RAI 03.07.02-24, Supplement 2**QUESTION:****Follow-up Question to RAI 03.07.02-15 (STP-NRC-100036)**

UHS Basin and RSW Pump House:

SUPPLEMENTAL RESPONSE:

UHS Basin and RSW Pump House (Part 1a):

Figure 03.07.02-24.99: Comparison of Z - Direction Raw Response Spectra for Original Mesh Node 16544, Empty Basin Upper Bound Soil - PH Roof - 5% Damping

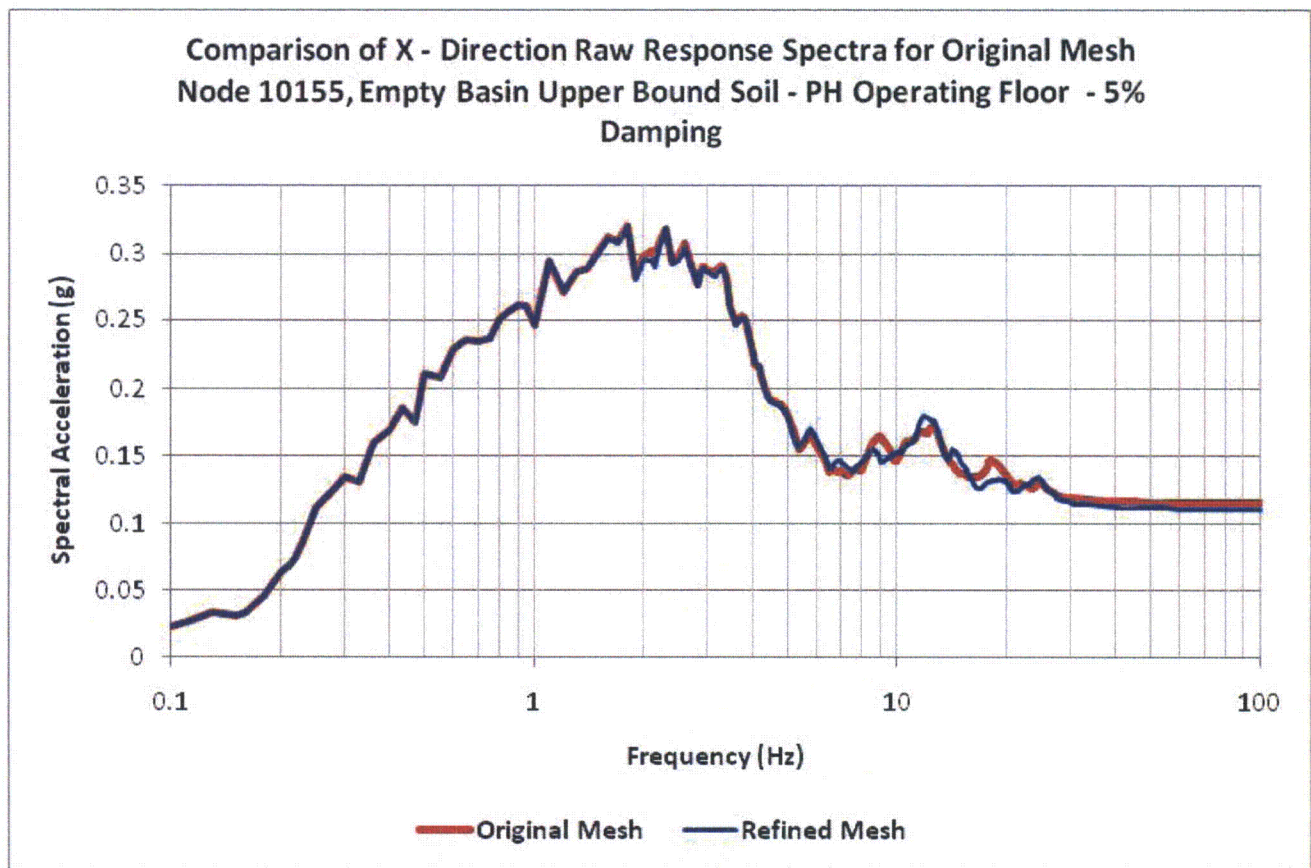
- Vertical direction spectra at the center of the Pump House Roof (see Figures 03.07.02-24.48 and 03.07.02-24.99)
- Vertical direction spectra at the center of the Pump House Operating Floor (see Figure 03.07.02-24.54)
- Vertical direction spectra of the Cooling Tower Walls (see Figures 03.07.02-24.69 and 03.07.02-24.120)
- Out-of-plane horizontal spectra of the UHS Basin Walls (see Figures 03.07.02-24.65 and 03.07.02-24.116)

Based on the above, modifications are warranted for the existing UHS/RSW Pump House response spectra for the above 4 cases.
